Addendum No. 3

"Phase 1a – Contract B – RAW Water Transmission Main"

Illinois Alluvial Regional Water Company
Jersey County, Illinois

H&A File No. 71000-400 Contract "B"
June 5, 2025

2 / CD2 **BLOW-OFF HYDRANT DETAIL**

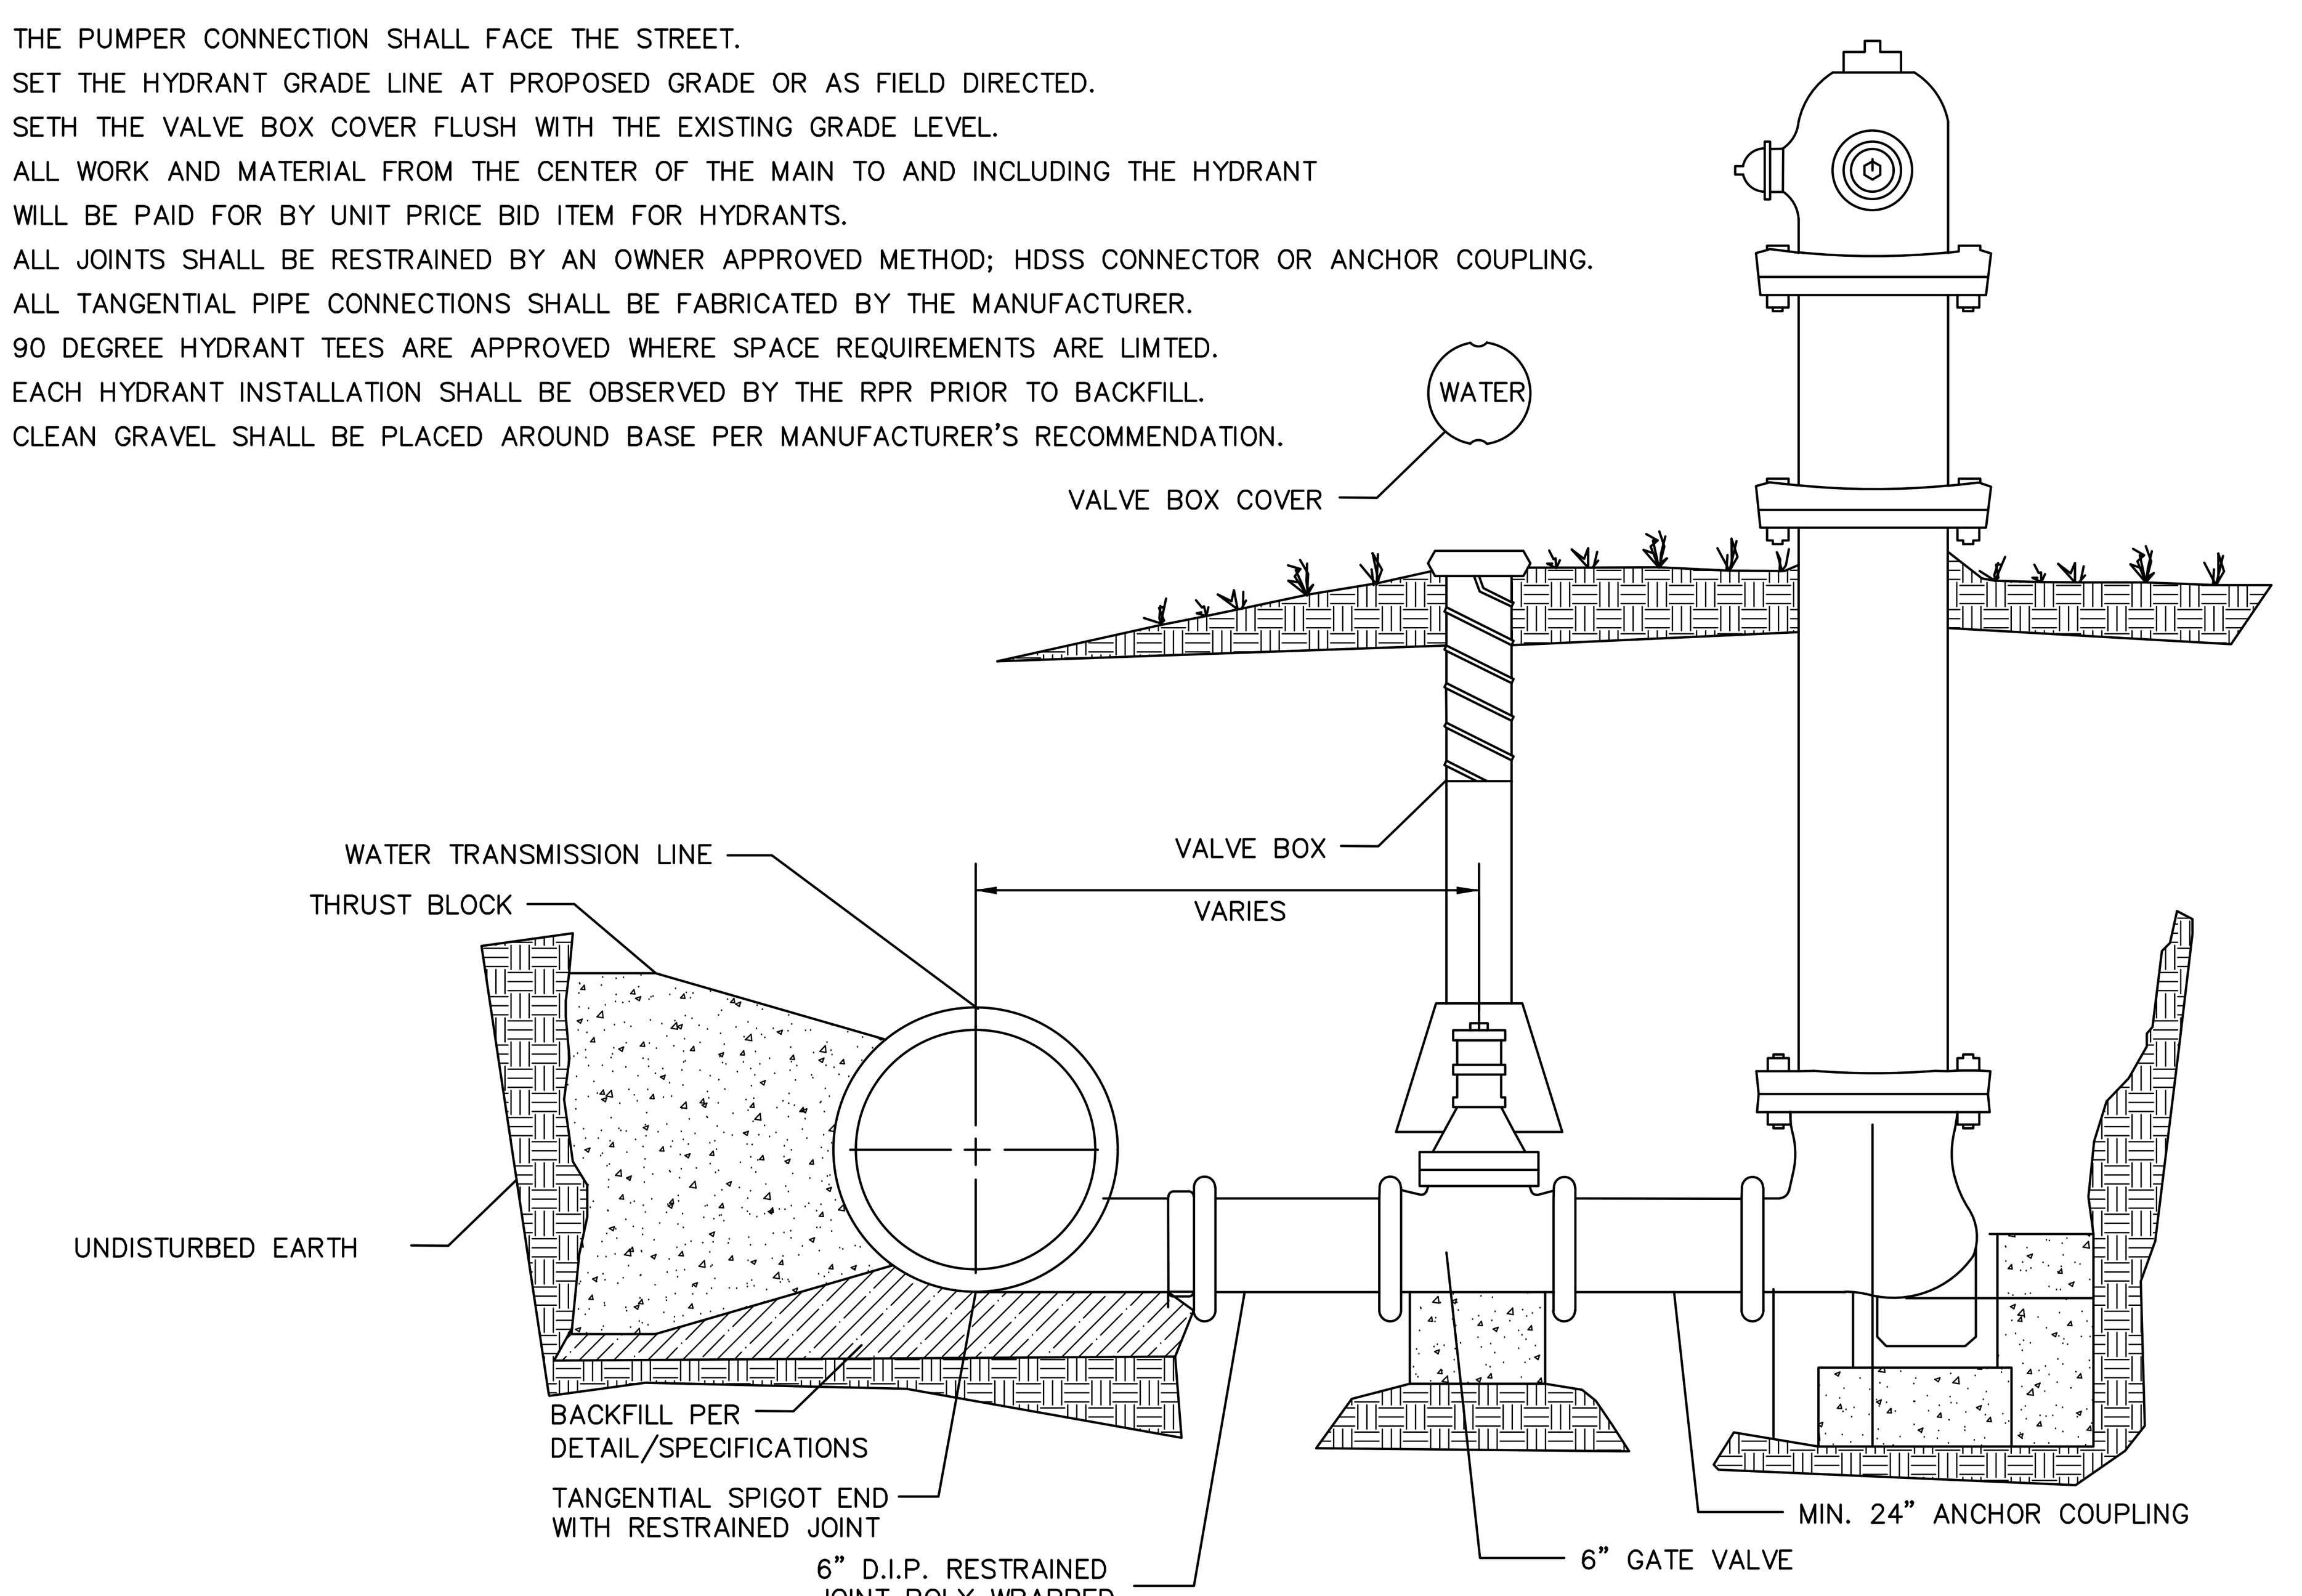
- **Sheet CD2** – The Blow-Off Hydrant Detail currently shows a tangential tee. A reducing tee with a downward outlet and a 90-degree bend may be used in place of the tangential tee.

4 / CD2 **COMBINATION AIR RELEASE/VACUUM VALVE DETAIL**

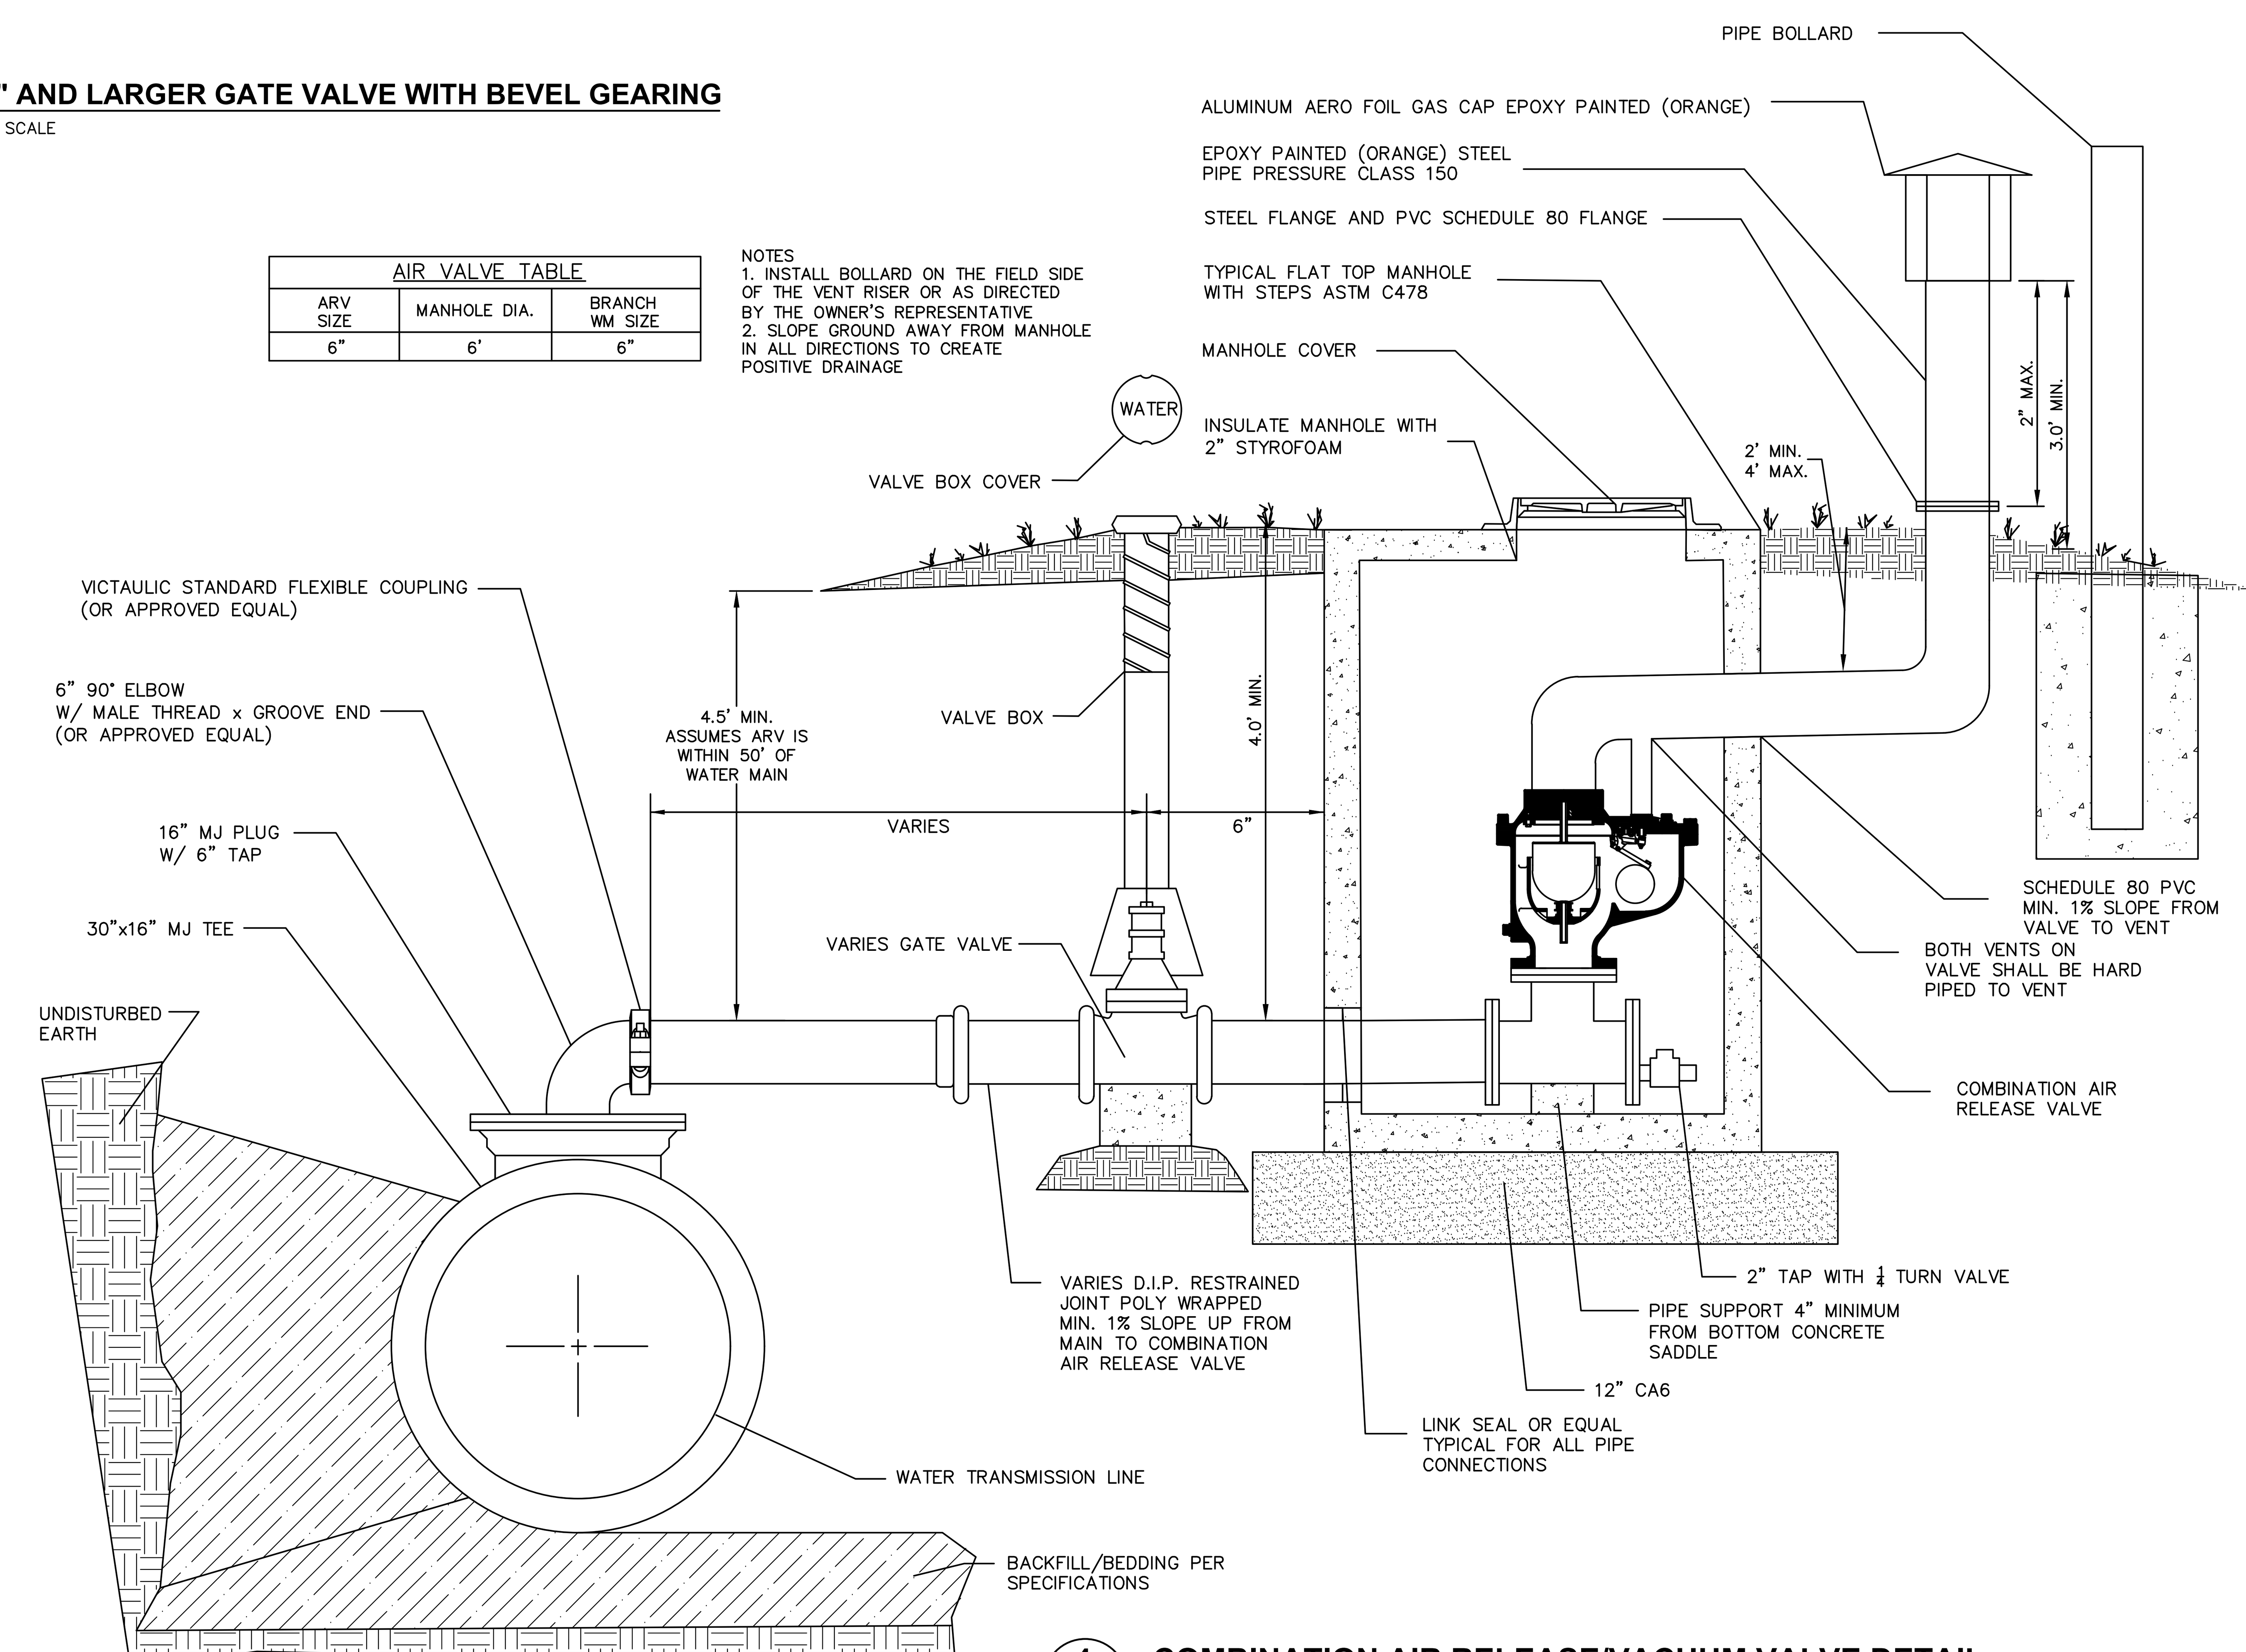
- **Sheet CD2** – The tangential fitting for the Combination Air Release/Vacuum Valve Detail has been removed and replaced with a reducing MJ tee/threaded 90 degree bend configuration.
